Access Compliance Report

Public Rights-of-Way

(Curb Ramps)

Intersection ID: 5967	Main Street: N_TRYON_ST	Cross Street: MCCULLOUGH_DR	Location: SW
ADA ID: 65533E585050	Ramp Type: Perpendicular	Initial Pass/Fail: Fail	Overall Compliance: No
Codes/Mitigation Info/Possible Solution		Field Measurements/Component Compliance	
Severity Score: 8.75

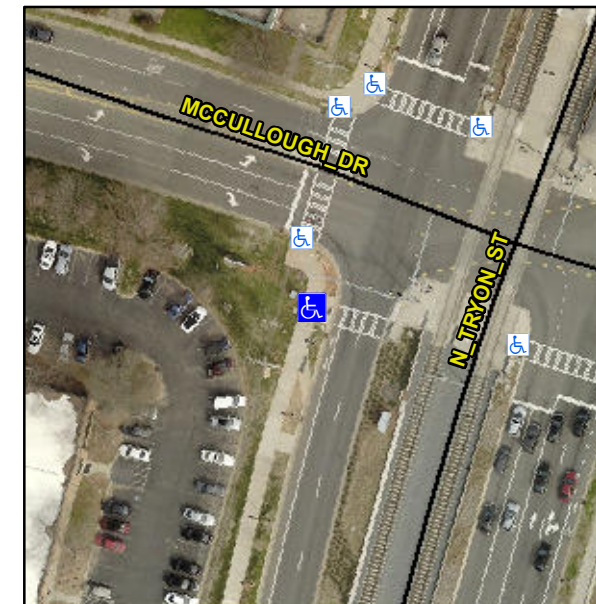
Not Found, R304.5.1

Compliance	Description	Data	Compliance	Description	Data
N/A	Ramp Length (in)	83.5	Yes	Ramp Slope (%)	6.9
No	Ramp Width (in)	47.0	Yes	Ramp XSlope (%)	0.2
N/A	Flare Type LT	N/A	N/A	Flare Type RT	N/A
N/A	Flare Slope LT (%)	N/A	N/A	Flare Slope RT (%)	N/A
N/A	Flare Traversable LT?	N/A	N/A	Flare Traversable RT?	N/A
N/A	Landing Length (in)	N/A	N/A	DWS Provided?	N/A
N/A	Landing Width (in)	N/A	N/A	DWS Contrast?	N/A
N/A	Landing Slope (%)	N/A	N/A	DWS Length (in)	N/A
N/A	Landing X Slope (%)	N/A	N/A	DWS Full Width?	N/A
N/A	Landing Curb? (Y/N)	N/A	N/A	DWS Offset (in)	N/A
N/A	Shared Landing?	N/A			
N/A	Gutter Ponding?	N/A	N/A	Gutter Slope (%)	N/A
N/A	Gutter Lip Ht (in)	2.0	N/A	Gutter X Slope (%)	N/A
N/A	Painted X Walk1?	No	N/A	Painted X Walk2?	N/A
	X Walk 1 Direction	To SE		X Walk 2 Direction	N/A
N/A	X Walk 1 Width (in)	N/A	N/A	X Walk 2 Width (in)	N/A
	X Walk 1 Slope (%)	1.9		X Walk 2 Slope (%)	N/A
	X Walk 1 X Slope (%)	0.7		X Walk 2 X Slope (%)	N/A

Remove & Replace Entire Ramp.
